Date	10 February 2026
To	Jon Bright, Project Director – Waitaha Hydro Scheme Westpower Ltd
From	Murray Hicks (Earth Sciences New Zealand, formerly NIWA)
Project advice provided for	<i>Waitaha Hydro Scheme</i>
Qualifications	<i>BSc (Hons), BE (Hons, Civil), PhD, provided in Appendix 19: Sediment Report</i>
Code of Conduct	<i>Provided in Appendix 19: Sediment Report</i>
Documents referred to	<i>Waitaha Hydro Scheme Substantive Application Appendix 19: Sediment Report¹</i>
Signature

1. I have read the peer review reports of Dr Jon Tunnicliffe and Mr Paul Morgan. I focus here on the Tunnicliffe report since that underpins the sediment-related issues raised in the Morgan report. Hence, I do not respond to any specific matters in the Morgan report as they follow my responses and conclusions to the Tunnicliffe report.

Review of River Geomorphology (Jon Tunnicliffe report)

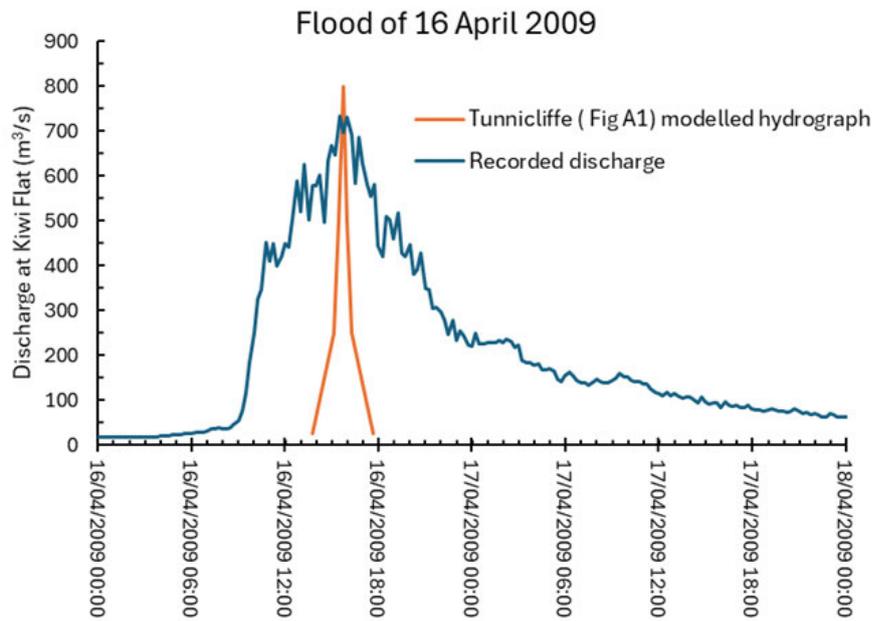
- (b) Secondly, his Figure A1 in his Appendix A highlights in my opinion an issue with his modelling which misleads on the timing and duration of bedload transfer along the lower part of Kiwi Flat. The issue is that the modelled flood is of un-naturally short duration. On his modelled hydrograph, flows rise between 250 m³/s and the 800 m³/s peak in only ~ 30 minutes and fall back again over the same time (~ 1 hour total duration). Figure 1 below (from data supplied by Mr Doyle) compares this modelled hydrograph with a real hydrograph from the Waitaha record with a similar peak discharge of 734 m³/s. The natural flood lasted ~ 14 hours above 250 m³/s.

16. On the rising limb of a flood it takes time (~ 15-20 minutes) for the inflow into the top of Kiwi Flat to translate down to Morgan Gorge. When the choking develops at the gorge it takes more time for the water to “bulk-up” in the backwater reach. Likewise, when the choking fades at the gorge on the flood recession it also takes time for the ponded water to drain. The duration of these response times for choking and unchoking depend on the “accommodation space” and the excess inflow over outflow but appear to be of the order of half to one hour (I provide evidence of this below). In the case of the Dr Tunnicliffe’s modelling, the flood is so short that I believe the backwater has not the time to fully develop until at or after the flood peak (Figures A1d and A1e in his Appendix A) and lingers down the recession while it drains (Figure A1f in his Appendix A).

17. In my opinion, Dr Tunnicliffe's assessment gives the false impression that bedload transport between upper Kiwi Flat and Morgan Gorge only connects during rising flood stages and does not connect on recessions. In contrast, natural Waitaha floods with peak discharges similar to the one modelled by Dr Tunnicliffe last some 10X longer, providing time for the backwater to develop on rising stages and to drain-away part-way down recessions – permitting bedload connection on both rising and falling hydrograph limbs. Moreover, the natural recessions are less steep than his modelled recession, providing a longer period of time for the unchoked recession flow to rework bedload down the lower flat into the gorge.

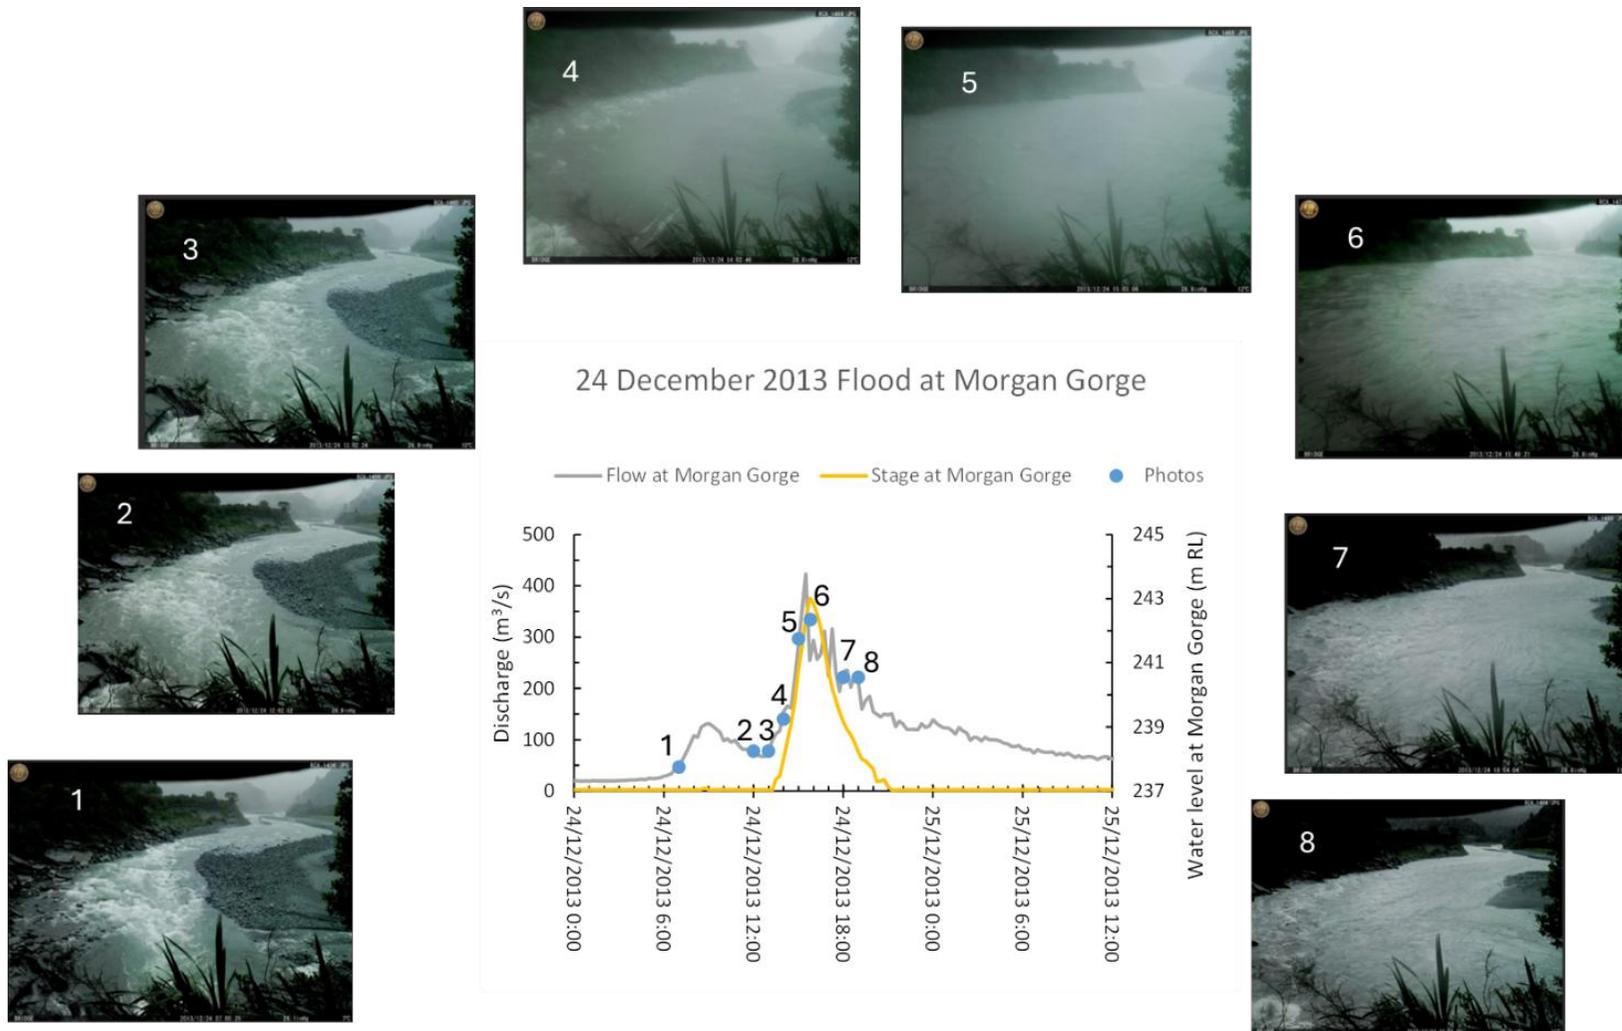
18. The natural choking behaviour is well illustrated by a sequence of photographs taken at the Morgan Gorge entrance during a flood in December 2013 (data supplied by Mr Doyle). These are shown on Figure 2, along with the discharge and water level at the gorge inlet. This sequence shows the choking developing on the rising limb, evident by the flooded river channel and the disappearance of “white-water” waves on the flow surface (including the drowning of the flow over the bedrock platform in the bottom left corner) between images 4 and 5, spanning a period of 1 hour. It then shows the choking fading on the recession at flows of around 220 m³/s between images 6 and 7, spanning a period of about 2 hours. This event was a relatively small one (discharge peaked at 423 m³/s) and lasted only about 7 hours, but there was clearly ample opportunity for bedload connection on the recession as well as on the rising limb, before and after the choked phase.

Figure 3: Dr Tunncliffe's Figure 1.

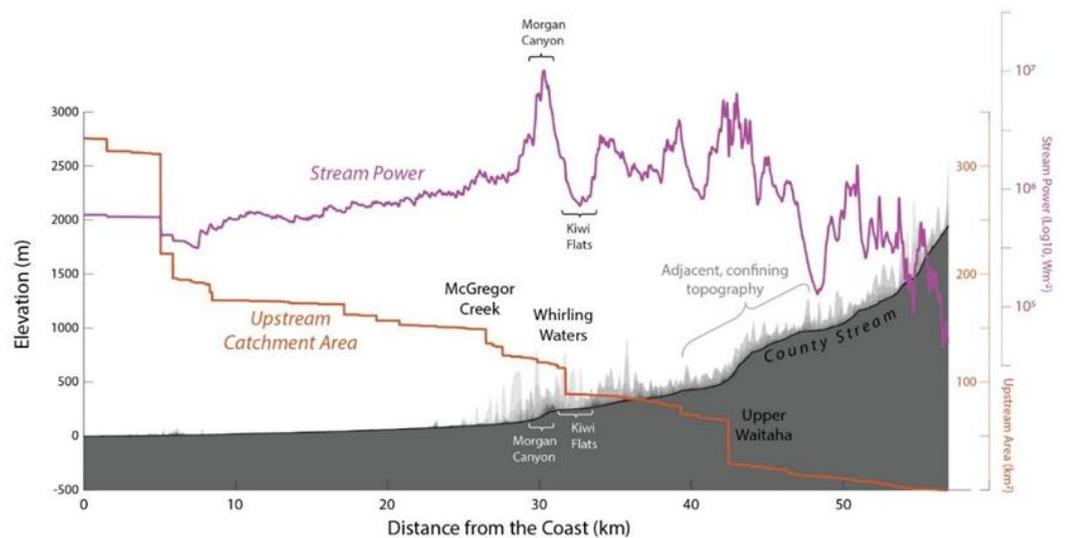
22. First, close examination of this plot shows that in fact the stream power is lowest upstream of the Whirling Waters confluence (which is

located at the sudden jump on the underlying catchment area graph), it receives a sharp boost as the Whirling Waters flow is added, and it rapidly increases downstream from there towards the gorge. This confirms that the geomorphic “node” transcends a zone rather than being a single point.

23. Second, the stream power values appear to be too large. For example, on Dr Tunnicliffe’s Figure 1 the stream power minimum at Upper Kiwi Flat is approximately $7 \times 10^5 \text{ W/m}^2$. Using the field-measured slope (S) of ~ 0.009 , using $\sim 30 \text{ m}^3/\text{s}$ for the mean discharge (Q), and with water density (ρ) = 1000 kg/m^3 and the gravitational acceleration (g) = 9.81 m/s^2 , then stream power = $2.7 \times 10^3 \text{ W/m}^2$ – a factor of X260 smaller than the reviewer’s value. Even using a higher discharge (say $812 \text{ m}^3/\text{s}$ to match the mean annual flood at Morgan Gorge), the discrepancy would still be a factor of X10. Therefore, I am unclear where the reviewer’s numbers come from.

24. Setting these matters aside, however, and accepting the longitudinal pattern illustrated by Dr Tunnicliffe’s stream power profile, converting back from the plot’s log-scale shows that the stream power in the vicinity of the proposed power station (at $\sim 28 \text{ km}$ from the coast) is $\sim 2\text{X}$ higher than the low value at upper Kiwi Flat (at $\sim 32 \text{ km}$ on the plot) and increases upstream from the power station to $\sim 13\text{X}$ higher at the steepest part of Morgan Gorge. Allowing that the river along Kiwi Flat upstream of Whirling Waters, where the stream power is at its minimum, is in a state of dynamic equilibrium between bedload supply and transport capacity (as indexed by stream power), then the much higher stream power values between there and the power station site indicate that the river has excess transport capacity all along the abstraction reach. In my opinion, that is confirmed by the predominantly boulder-armoured channel along the abstraction reach in contrast to the more abundant proportions of gravel and coarse sand (which dominate the bedload) in the upper Kiwi Flat channel (compare Figures C-4 and C-9 in the Sediment Report)⁸. This illustrates to me the resilience of the abstraction reach channel to quickly pass any transient accumulation of gravel and sand stemming from the Project operations. Indeed, the bracketed note at the end of

Figure 4: Short pools below the Glamour Glen confluence in the residual flow reach. White water plumes show “jets” of high momentum inflow that energises secondary circulation and turbulence in the pools. Flow direction is up the page. Source Google Earth.

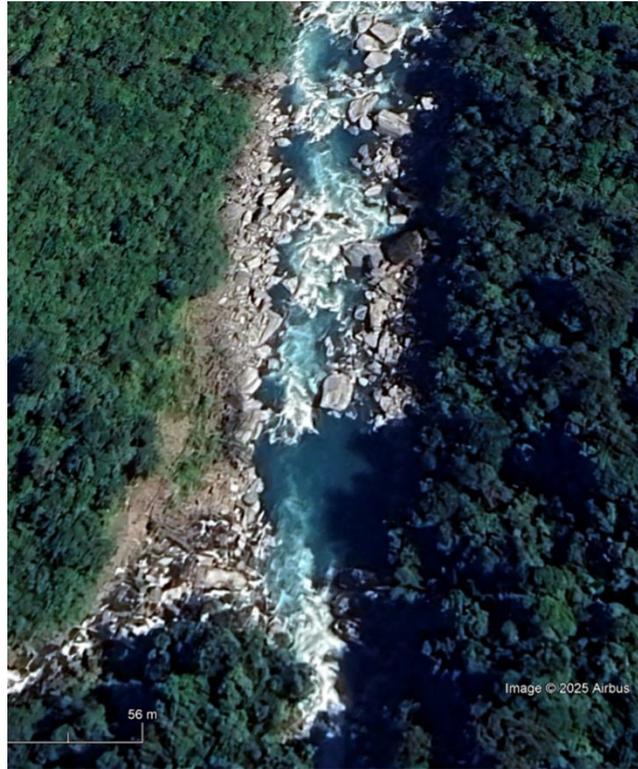
34. Dr Tunnicliffe comments that the analysis of fine sediment effects fails to account for spatial heterogeneity of sediment deposition. Spatial heterogeneity in sediment deposition was accommodated in the Sediment Report's analysis (Section D.2)¹² to the level of physical habitat type. This was done by assigning different "effective depositional widths" to each physical habitat type, with deposition occurring over a wider proportion of the wetted width of the slow run habitat than in the fast bouldery run habitat. That produced greater masses of deposition per m channel length in the slow run habitat but the same deposit thickness because the width of channel experiencing deposition was wider. Furthermore, it is relevant that the environmental flow analysis of Allen and Hay (2013)¹³ did not identify any "pool" habitat in the abstraction reach, at least in the context of a pool being a segment of deep, slow velocity flow. Confirming this, while several "pools" can be seen on Google Earth Imagery of this reach (e.g., **Figure 4**), they are short and fed by flow jets that generate strong secondary circulation and turbulence in the pool (both of which entrain sediment) even if the mean streamwise flow velocity may be relatively low.

- (a) There are always micro-environments in the natural Waitaha environment where fine, potentially cohesive sediment might collect under the existing regime (e.g. Figure 2.3 in the Sediment Report¹⁵),

but there is no evidence that such deposits are widespread or last longer than the next fresh.

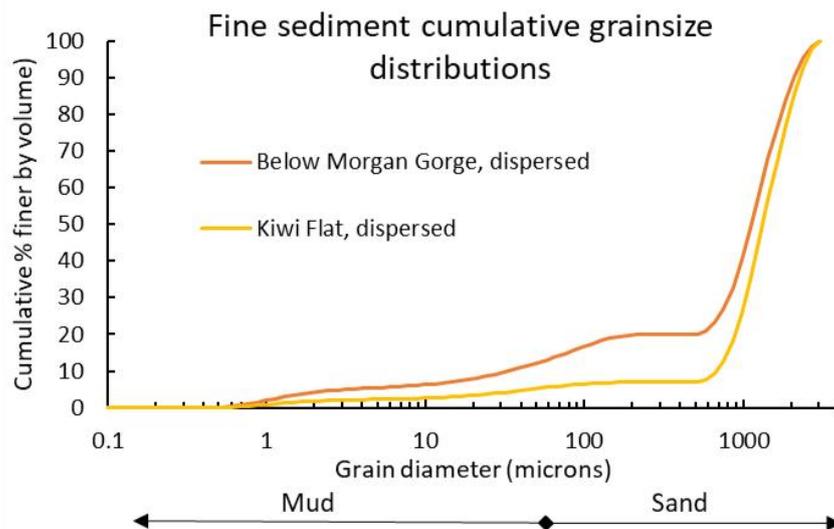
- (b) Cohesion-developing clay minerals travel as “wash load” in steep mountain rivers like the Waitaha and its West Coast neighbours, meaning they remain in suspension during freshes and floods and will be the last to deposit from suspension even in local, low-velocity environments. Indeed, fine sediment samples collected in 2024 from low velocity patches at Kiwi Flat and immediately below Morgan Gorge were, even after treating with chemical dispersant to break-apart flocs of cohesive grains, at least 86% sand grade so had only minor content of potentially cohesive mud (**Figure 5**).
- (c) Section D4 of the Sediment Report¹⁶ notes that the mud content of a gravel bar sample in the Whataroa was only 0.52%, and I expect similar levels of mud “embeddedness” in gravelly bars and patches from Morgan Gorge to the power station.
